Access Compliance Report

Public Rights-of-Way

(Curb Ramps)

Intersection ID: 46818	Main Street: HOLM_OAK_PL	Cross Street: AZALEA_HILLS_DR	Location: SE
ADA ID: 444189A4207D	Ramp Type: PerpDiag	Initial Pass/Fail: Fail	Overall Compliance: No
			Severity Score: 26.25

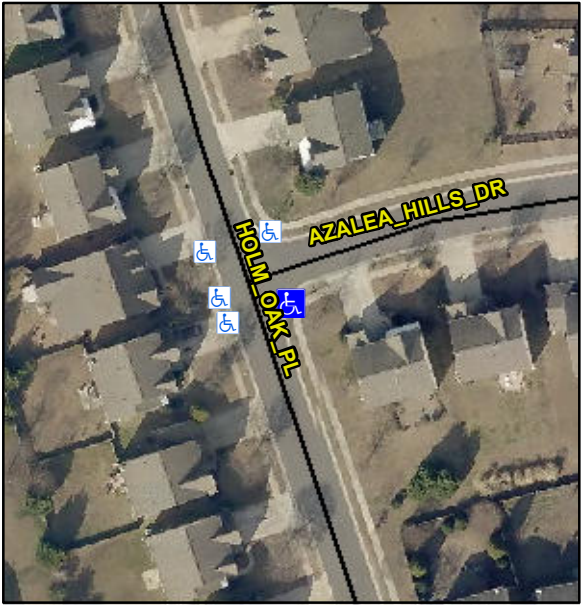
Codes/Mitigation Info/Possible Solution			Field Measurements/Component Compliance		
	Possible Solutions:		Compliance	Description	Data
	Remove & Replace Curb Ramp With Two New Directional Ramps or Equivalent.		No	Ramp Length (in)	46.5
			Yes	Ramp Width (in)	51.5
			N/A	Flare Type LT	N/A
			N/A	Flare Slope LT (%)	N/A
			N/A	Flare Traversable LT?	N/A
			N/A	Landing Length (in)	N/A
			N/A	Landing Width (in)	N/A
			N/A	Landing Slope (%)	N/A
			N/A	Landing X Slope (%)	N/A
Surveyor Notes: N/A PROW/ADA: R304.2.2, R304.5.3			N/A	Flare Type RT	N/A
			N/A	Flare Slope RT (%)	N/A
			N/A	Flare Traversable RT?	N/A
			N/A	DWS Provided?	N/A
			N/A	DWS Contrast?	N/A
			N/A	DWS Length (in)	N/A
			N/A	DWS Full Width?	N/A
			N/A	DWS Offset (in)	N/A
			N/A	Gutter Ponding?	N/A
			N/A	Gutter Lip Ht (in)	N/A
Total Cost: \$ 3200.00			No	Painted X Walk2?	No
			N/A	X Walk 1 Direction	To N
			N/A	X Walk 2 Direction	To W
			N/A	X Walk 1 Width (in)	N/A

N/A	X Walk 2 Width (in)	N/A
			9.1	X Walk 1 Slope (%)	6.6
			1.2	X Walk 2 Slope (%)	3.6
			N/A	X Walk 1 X Slope (%)	3.6
			N/A	Ramp inside XWalk1?	N/A
			N/A	Ramp inside XWalk2?	N/A

3.2	Road Slope (%)	N/A
			11.1	Road X Slope (%)	N/A
			N/A	Clear Space?	N/A
			N/A	Clear Space to XWalk (in)	N/A
			N/A	Storm Grate/Utility Hazard?	N/A
			N/A	Storm Grate/Utility Type	N/A
			N/A	Obstruction Type	N/A
			N/A	Obstruction Type	N/A
			Yes	Surface Condition? (G/P)	Good
